COMMUNITY DEVELOPMENT DEPARTMENT

HEARING DATE: 11/15/2022
 TO: Mayor & City Council
 FROM: Joseph Dodson, Associate Planner
 208-884-5533
 SUBJECT: H-2022-0047 & CR-2022-0006
 Bridgetower Multi-family CUP
 LOCATION: The site is located at S0427438410 on the north side of W. McMillan Road between N. San Vito Way and N. Vicenza Way, near the northwest corner of N. Ten Mile Road and W. McMillan Road, in the SE 1/4 of Section 27, Township 4N, Range 1W.

Request for Conditional Use Permit (CUP) for a multi-family development consisting of 235 units on 16.61 acres of land in the R-15 zoning district, by Alpha Development Group.

A. Site Plan (NOT APPROVED)

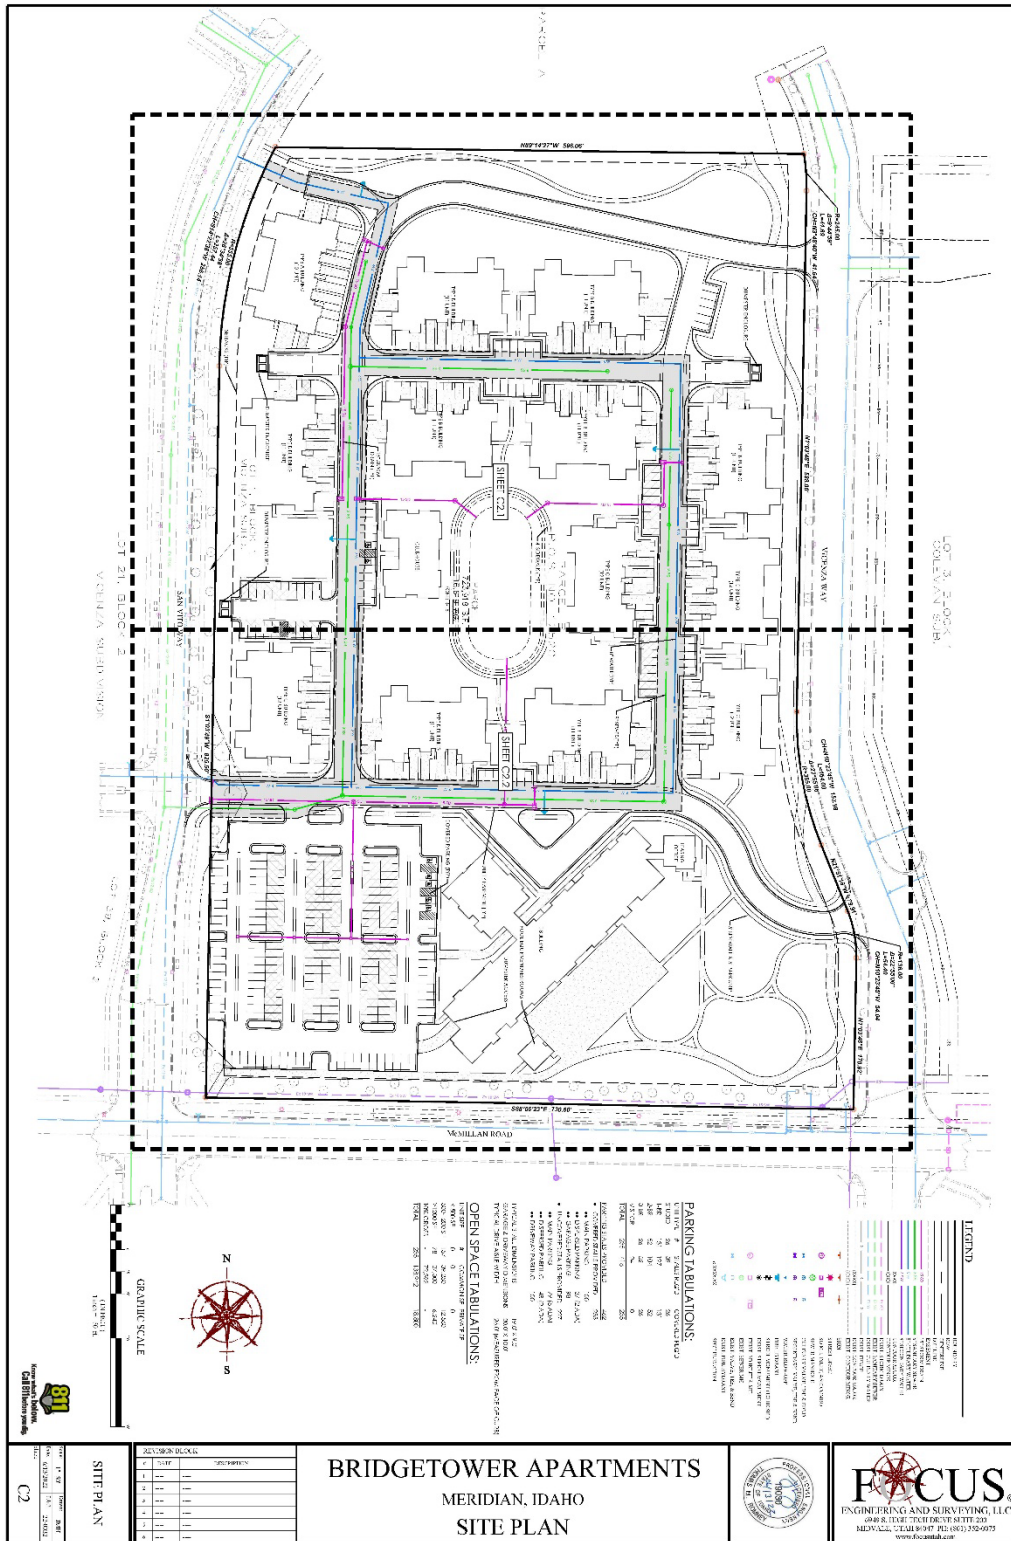
As noted above, it appears the internal sidewalks are 4 feet wide instead of 5 feet wide. Staff is recommending all of these are revised and shown as 5-foot wide with the future CZC application. In addition, the submitted plans depict the required multi-use pathway along the east boundary but not along the north boundary nor shows a connection to the existing detached sidewalk along McMillan, as required by Parks. The Applicant should revise all plans to show this 5-foot sidewalk as 10-foot and add a connection to the McMillan sidewalk with the future CZC application.

The drive aisle near the south end of the site connecting San Vito Way to Vicenza Way separates the townhome style product from the 3-story internally accessed apartment building. Staff has noted to the Applicant that some form of traffic calming should occur along this drive aisle to help with pedestrian safety; as currently proposed, Staff believe this drive aisle to be an unsafe area for residents to cross to access the amenities and open space located in the center of the development or the arterial sidewalk along McMillan.

For this reason, Staff is recommending revisions to this area of the site plan to help make this area safer:

- 1. Rotate the two center buildings that take access from this drive aisle 90 degrees to have their driveway accesses to the east and west instead;*
- 2. Relocate the 7 off-street parking stalls in this area to remove back-out parking altogether;*
- 3. Show at least two bulb-outs on this drive aisle to help choke this drive aisle for traffic calming with one of them being located where the north-south pedestrian facility is shown from the center of the site to the stacked building;
 - a. Make this crossing with different material per UDC 11-3A-19B.4 (i.e. brick, pavers, stamped/colored concrete) and with a table-top speed bump consistent with Fire department standards.**

4. *Staff would prefer the west north-south drive aisle align with one of the drive aisle entrances for the parking lot in the southwest corner of the property.*

2. With the future CZC application, the site plan included in Section VII.A, shall be revised as follows:
 - a. Show all sidewalks as a minimum 5 feet wide except for those required to be multi-use pathways;

- b. Depict a 10-foot wide multi-use pathway along the north and east boundaries that connect to the San Vito and Gondola intersection and to the existing arterial sidewalk along McMillan road near the southeast corner of the site; the sidewalk along the south boundary currently shown as 10 feet may be reduced to 5 feet per this condition.

- c. Show any pedestrian facility that crosses a drive aisle to be constructed in accord with UDC 11-3A-19B.4 (i.e. brick, pavers, stamped/colored concrete).

- d. Show the required maintenance storage area per the specific use standards (UDC 11-4-3-27).
 - e. Rotate the two south-center buildings that take access from the southern drive aisle 90 degrees to have their driveway accesses to the east and west instead.

- f. Relocate the 7 off-street parking stalls along the southern drive aisle to remove back-out parking in this area.
 - g. Show at least two bulb-outs on the south east-west drive aisle to help choke down this drive aisle for traffic calming with one of them being located where the north-south pedestrian facility is shown from the central open space area to the stacked "T" building.

- h. Realign the west north-south drive aisle with one of the drive aisle entrances for the parking lot in the southwest corner of the property.
 - i. Consistent with ACHD standards and future plan approval, the Applicant shall construct a Pedestrian Hybrid Beacon (PHB) crossing across McMillan Road at the San Vito and McMillan intersection prior to release of the first certificate of occupancy.

- j. Add an additional driveway connection to N. San Vito Way in alignment with W. Gondola Drive across the southwest corner of the adjacent property (S0427417210) to the north and extend the sidewalk to this intersection in accord with UDC 11-3A-3 and UDC 11-3B-9C.3. ~~If this connection cannot be constructed at this time, Applicant may stub driveway connection to shared property line and provide a cross access ingress/egress easement at its location for future connectivity.~~

- k. Depict existing access to San Vito Way in the southwest quadrant of the project to be an emergency-only access; obtain Meridian Fire Department approval for this access.

B. Landscape Plan

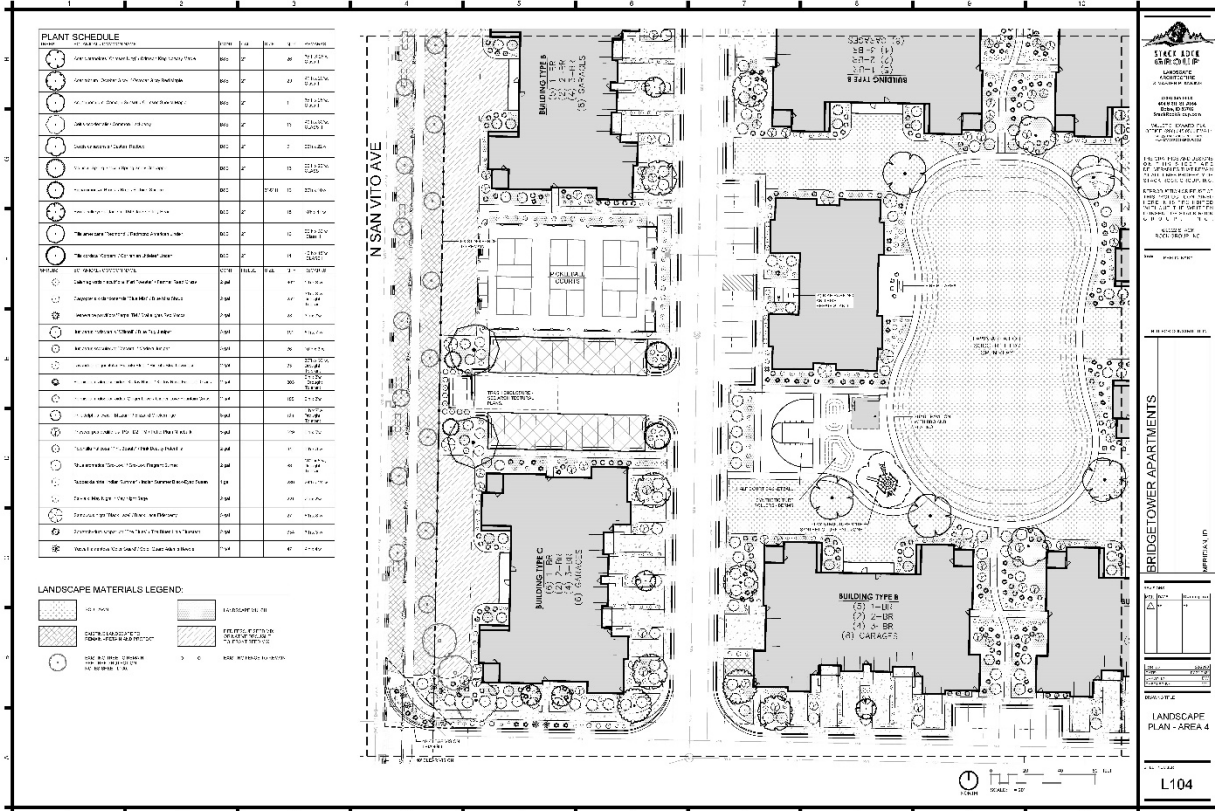
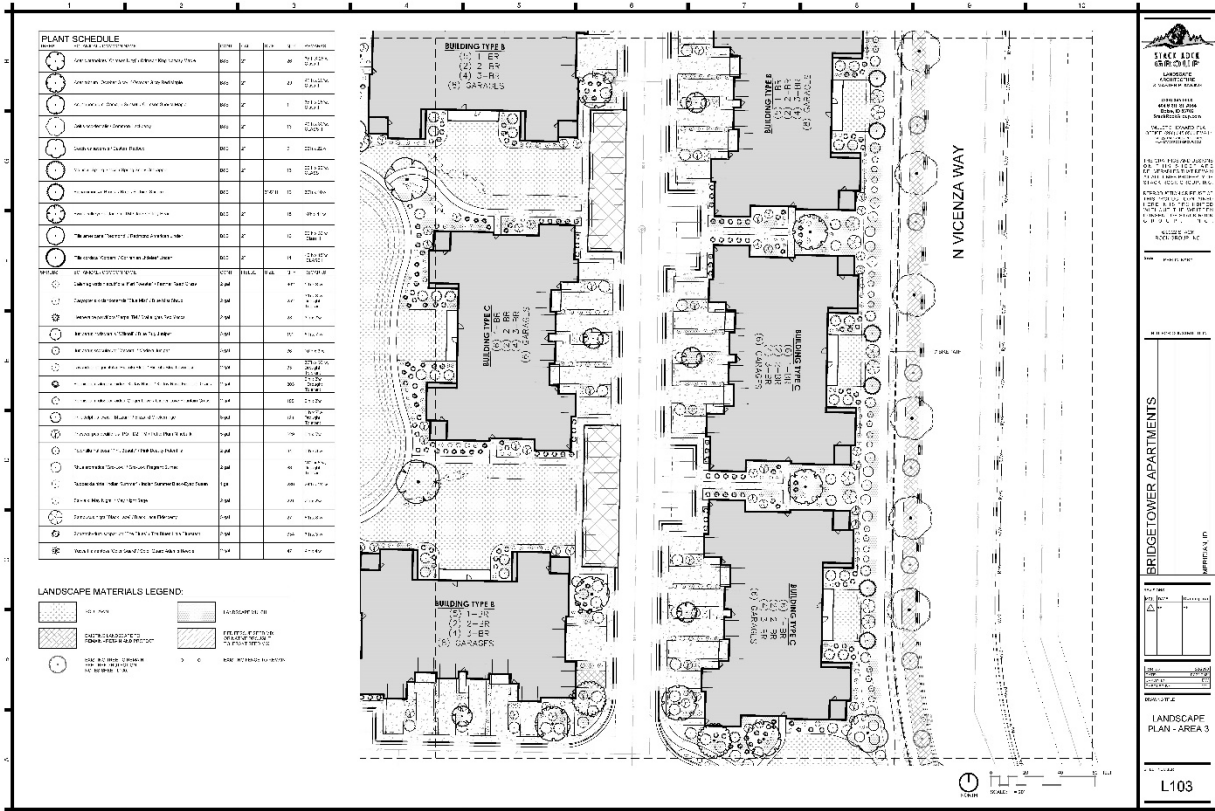
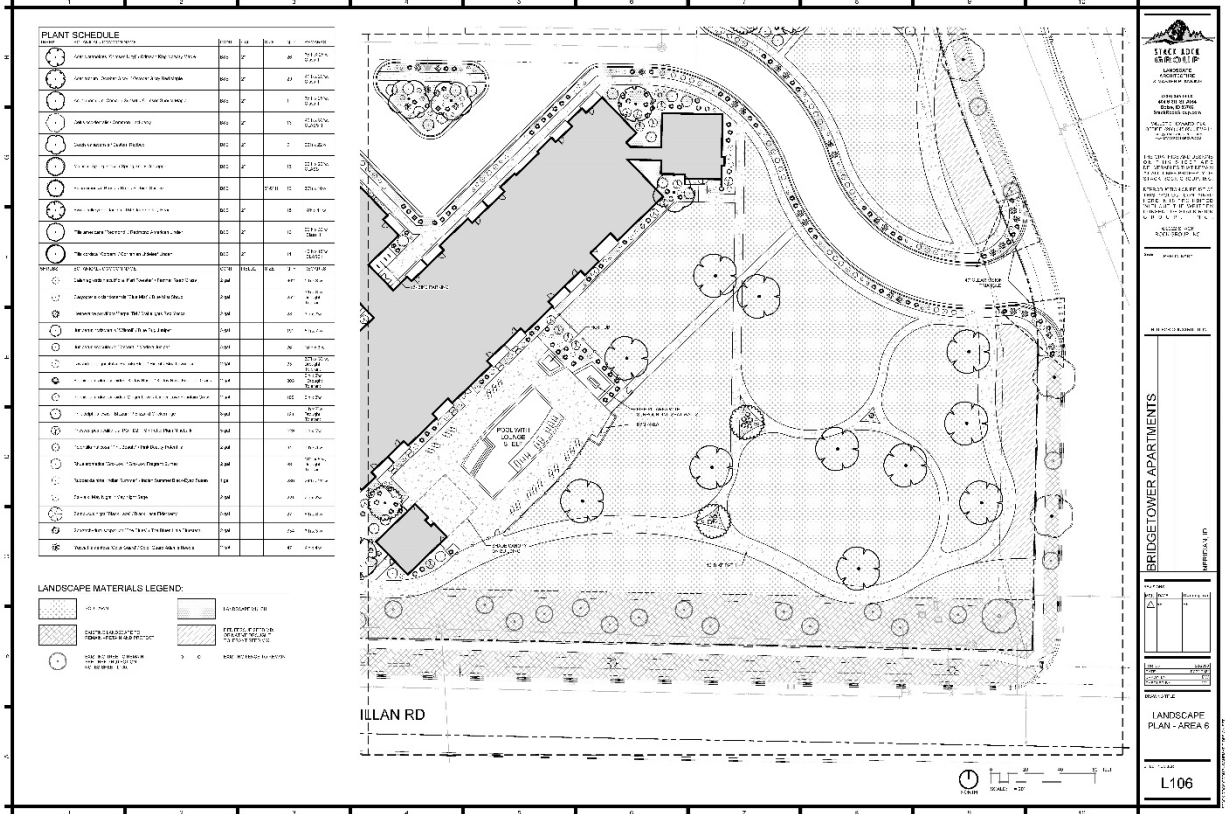
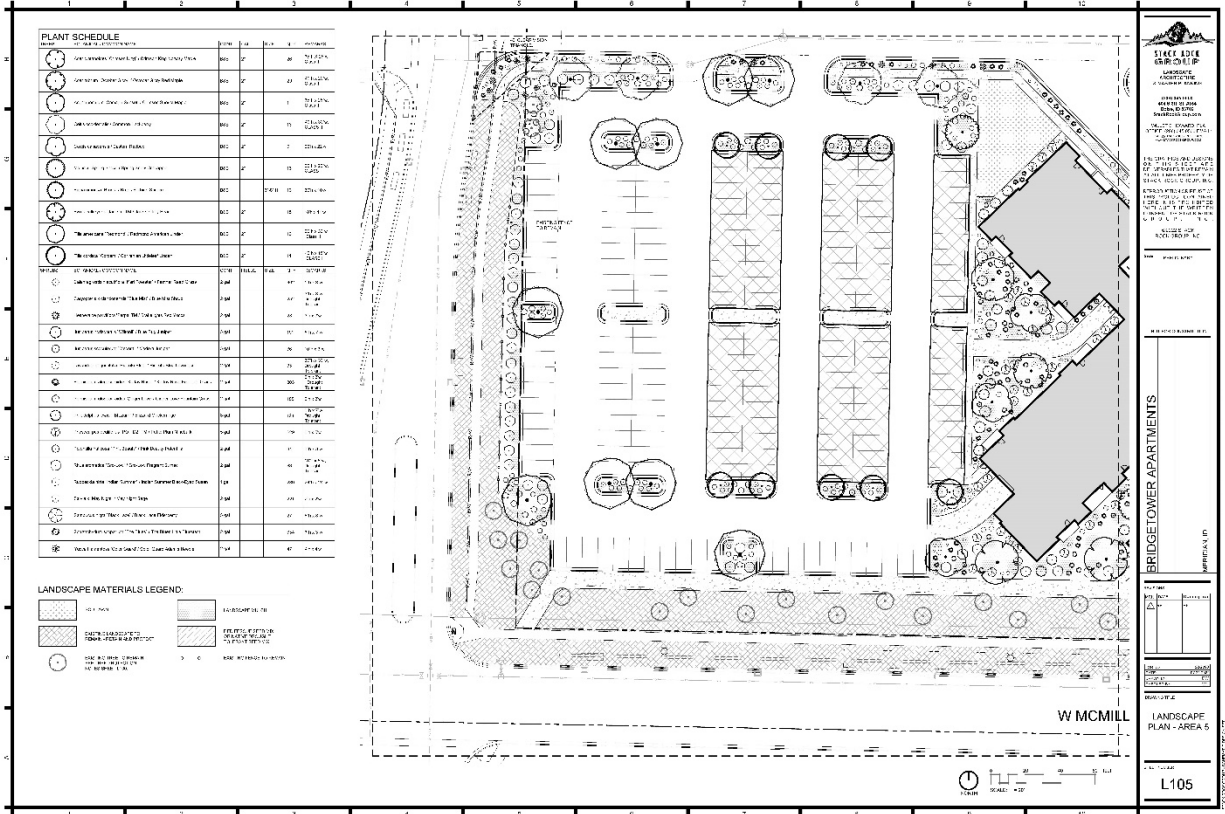
According to the submitted landscape plans, all required landscaping appears to be shown except for additional trees along the multi-use pathway segment that should be along the north boundary (required to be shown on future plans). The Applicant should add the required trees adjacent to this pathway along the north boundary when the plans are revised to include this additional pathway segment.

No new fencing is shown in the legend of the landscape plans but new fencing is depicted near the northeast corner of the site for the proposed dog park. The Applicant should correct the plans to depict the type of fencing proposed for the dog park area and to ensure compliance with UDC 11-3A-7. Any existing fencing is noted to be protected and remain on the site.

3. With the future CZC application, the landscape plan included in Section VII.B shall be revised as follows:
 - a. Revise the plans to reflect Staff's recommended changes above.

- b. Add any proposed fencing to the Landscape Plan legend (i.e. fencing proposed for the fenced dog park).
 - c. Depict the required street buffers along San Vito Way, Vicenza Way, and McMillan Road regardless of ownership status to ensure compliance with UDC dimensional standards in UDC Table 11-2A-7 and to be landscaped per UDC 11-3B-7.

- d. Add the required trees adjacent to the new multi-use pathway segment along the north boundary per UDC 11-3B-12.
4. With the future CZC application, revise the multi-plex elevations to reflect compliance with the required Architectural Standards per the analysis in the Building Elevations section above in Section V:

D. Building Elevations

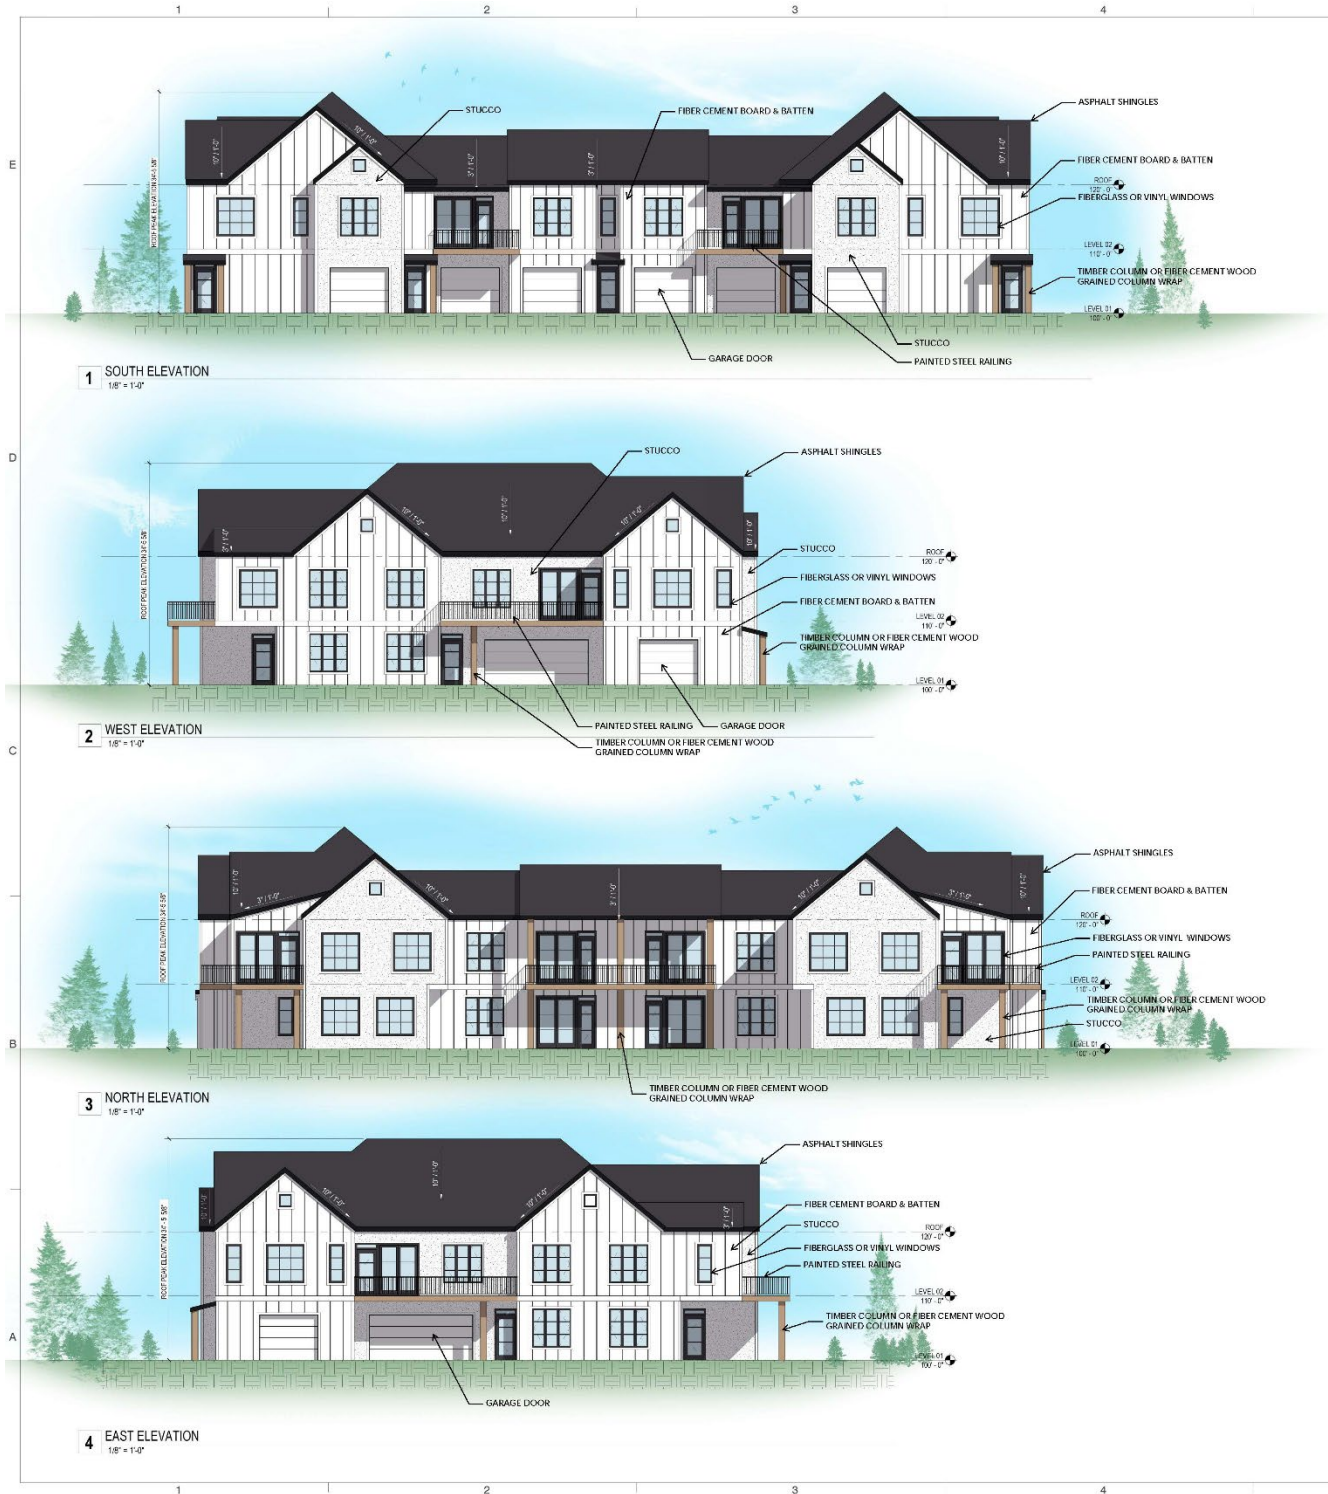
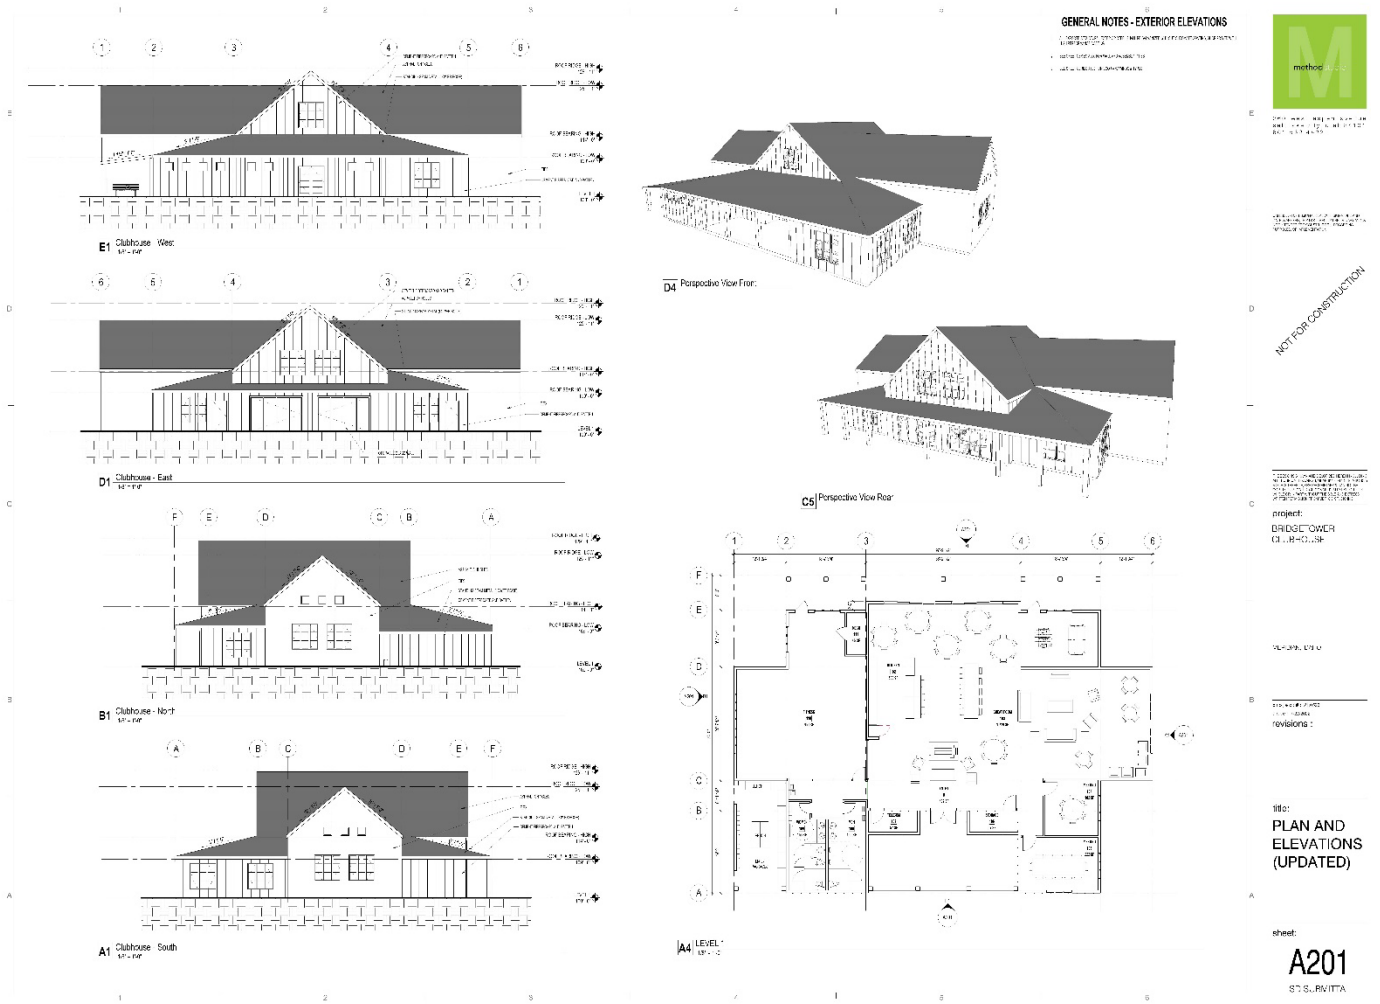
Staff has analyzed the submitted building elevations against the Architectural Standards Manual and finds the submitted elevations to be generally compliant. Staff is recommending specific revisions to be submitted with the future CZC application showing compliance with the following standards:

1. *R1.2A, 3.2D, & 5.2A – add additional color combinations or materials;*
2. *R3.4A – extend the roof overhangs or apply for a Design Standard Exception;*
3. *R5.2D – Comply; add qualifying masonry material along the base of the multi-plex buildings;*

- a. Add additional color combinations and materials to comply with R1.2A, 3.2D, & 5.2A;
 - b. Extend the roof overhangs or apply for a Design Standard Exception to comply with R3.4A;

- c. Add qualifying masonry material along the base of the multi-plex buildings to comply with R5.2D.
5. The Applicant shall submit a revised open space exhibit with the future CZC application that reflects the most up to date site plan, landscape plan, and any staff recommended revisions for the development.
